Application Ref: NP/21/0653/FUL

Case Officer	Jo Rees-Wigmore		
Applicant	Mr & Ms C & A Millership - Walwyn-Jones		
Agent	Mr A Sutton, Andrew Sutton Architecture		
Proposal	Proposed rear alterations & extension to dwelling, including new roof profile and dormer, changes to fenestration, with additional home office/garden/guest room & shed ancillary to dwelling		
Site Location	5, Woodside, Blue Anchor Way, Dale, Haverfordwest, Pembrokeshire, SA62 3RG		
Grid Ref			
Date Valid	01-Nov-2021	Target Date	29-Mar-2022

The application is referred to the Development Management Committee for determination as the officers recommendation differs from that to the Community Council's recommendation

The submitted application description proposes 'proposed rear alterations & extension to dwelling, with additional home office/garden room & shed ancillary to dwelling'.

PROPOSED ELEVATIONS

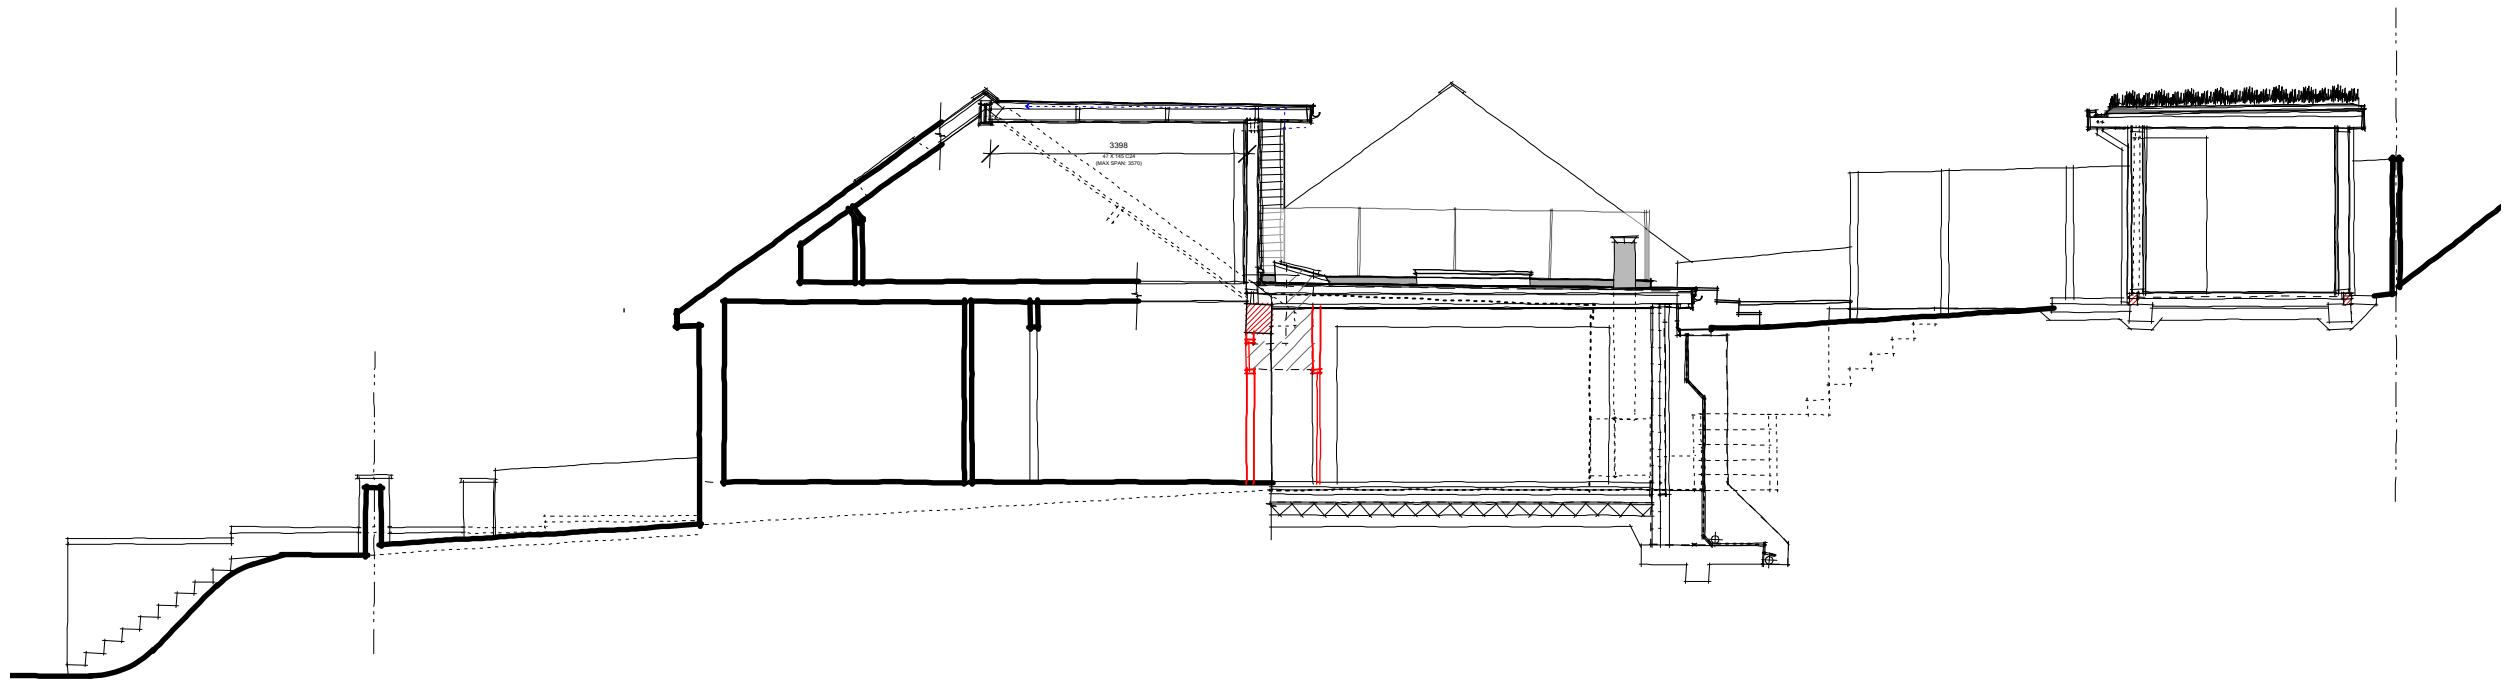
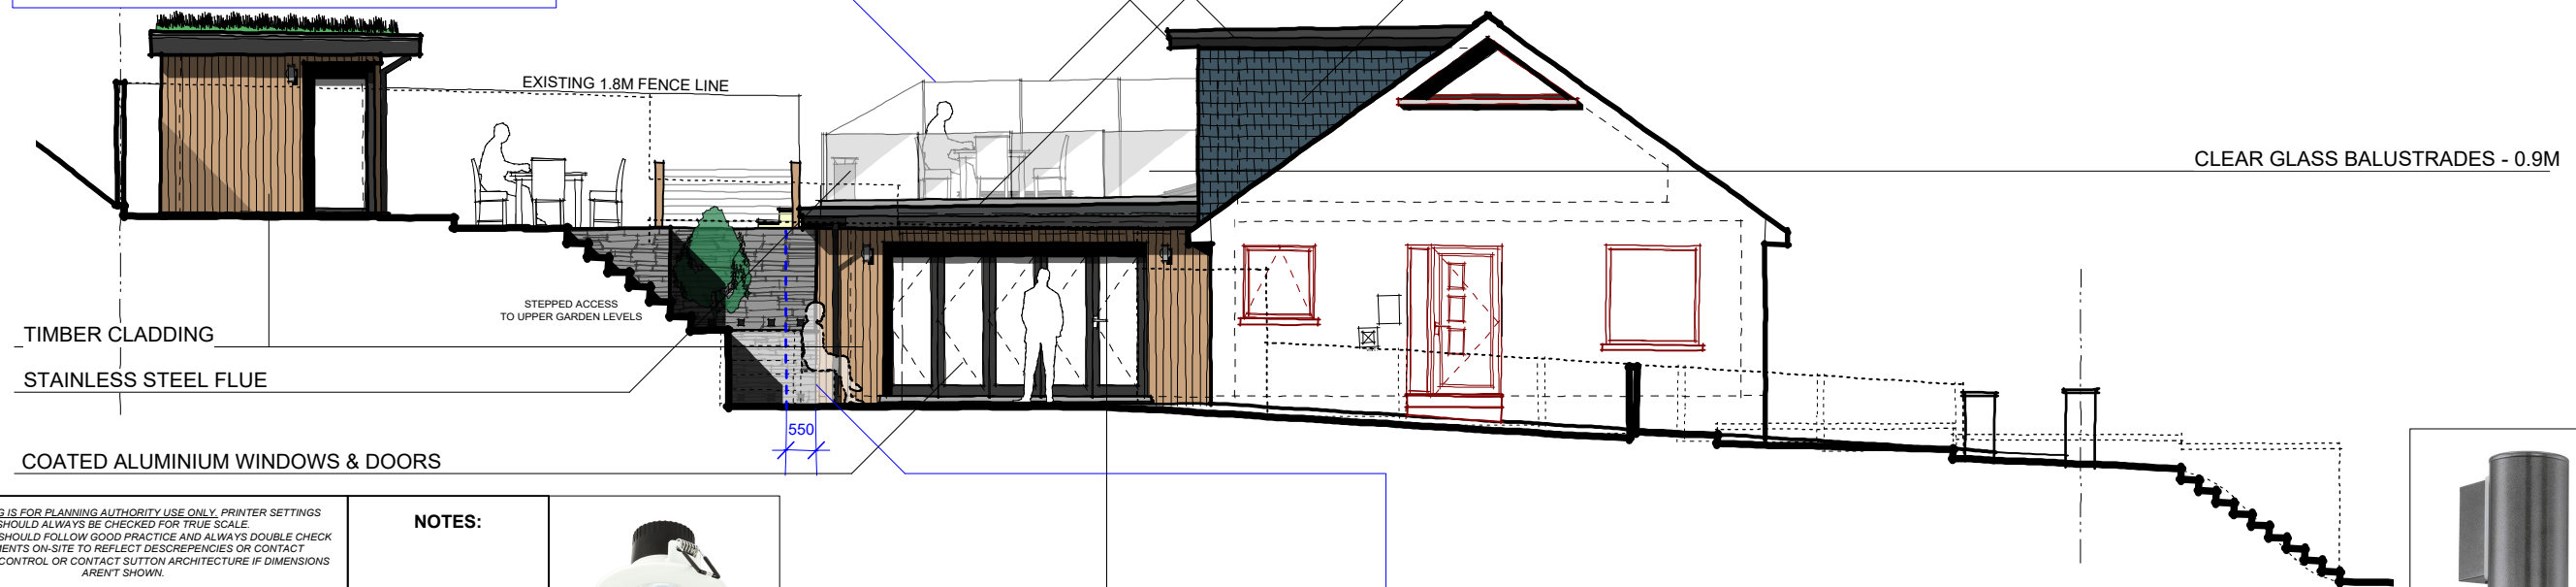
The proposed dormer is considered to be excessive in size and scale, overly large and to form a disproportionate and dominant addition to the dwelling that is bulky and prominent in form. This would potentially form a poor design precedent for this area of relatively modest and uniform dwellings.

The proposed balcony over the rear extension will allow for views directly into the rear garden area of number 4, adversely affecting the existing privacy standards. The proposed elevation plan shows the existing boundary screening will not be of a sufficient height to mitigate any overlooking

Whilst an obscured glass balustrade is proposed at 1.6m height, this is directly on the balcony and will not provide an acceptable level of privacy. As occupants standing on the balcony, may be able to have direct views into number 4.

AMENDED 07/02/22:
1.6M FROSTED PRIVACY SCREENS AT BOUNDARY;
SPACING REDUCED & END PANEL TO BE
CHAMFERED TO REDUCE VISUAL IMPACT TO
NEIGHBOURING PROPERTY

AMENDED 07/02/22:
REAR EXTENSION REDUCED BY 550MM.
1.6M FROSTED PRIVACY SCREENS RE-SIZED ACCORDINGLY

PROPOSED GARDEN ROOM PLAN SHOWN @ A3
SEABREEZE, NO.5 WOODSIDE, DALE
PROPOSED REAR ALTERATIONS & EXTENSION TO DWELLING,
WITH ADDITIONAL HOME OFFICE, GARDEN ROOM & SHED
ANCILLARY TO DWELLING

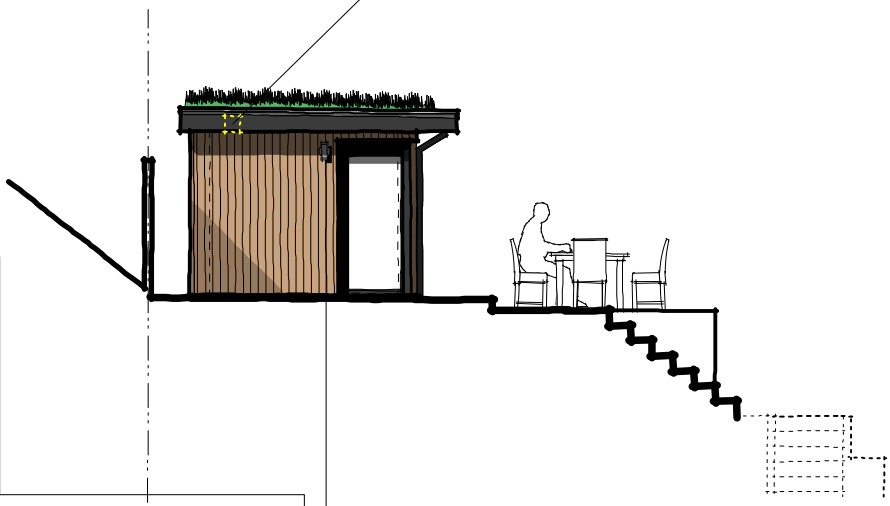
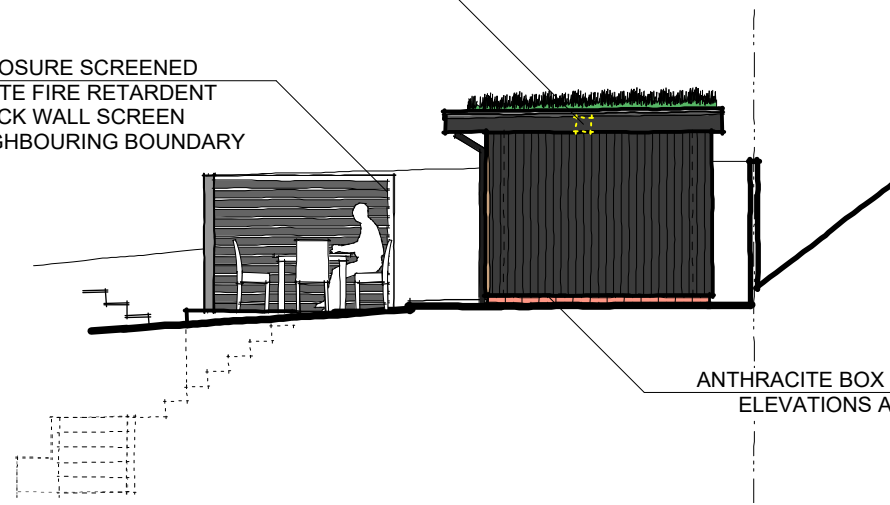
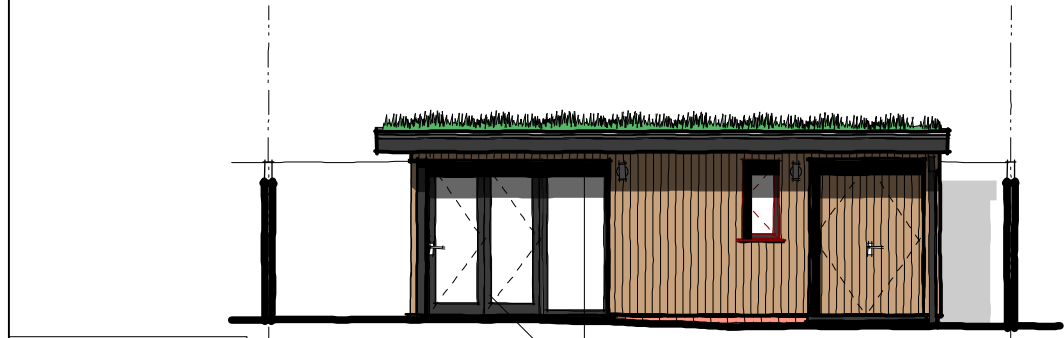
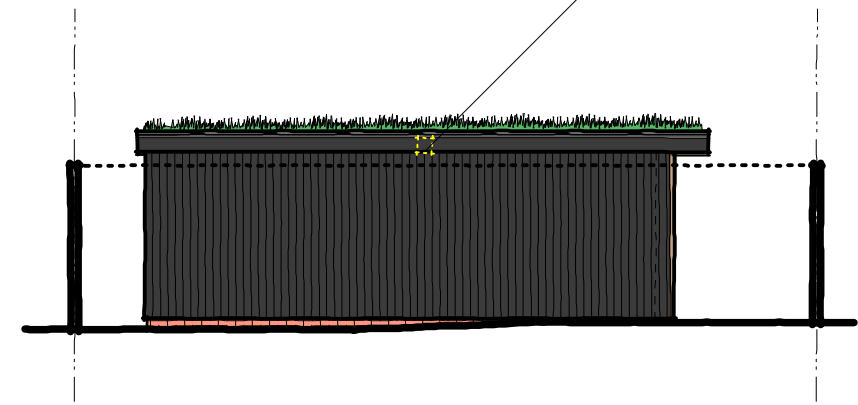
The garden room requires permission by virtue of its height and proximity to the boundaries. Whilst the garden room is at an oblique angle to the property to the east, it is only 6 metres away from the windows, and as such is likely to have a significantly overbearing impact.

Whilst proposed fencing has been suggested to address issues of overlooking into neighbouring gardens, this will not prevent views back towards the neighbouring adjacent houses and the raised nature of the garden room is such that these views back onto neighbouring properties will be both intrusive and out of character with the surrounding development.
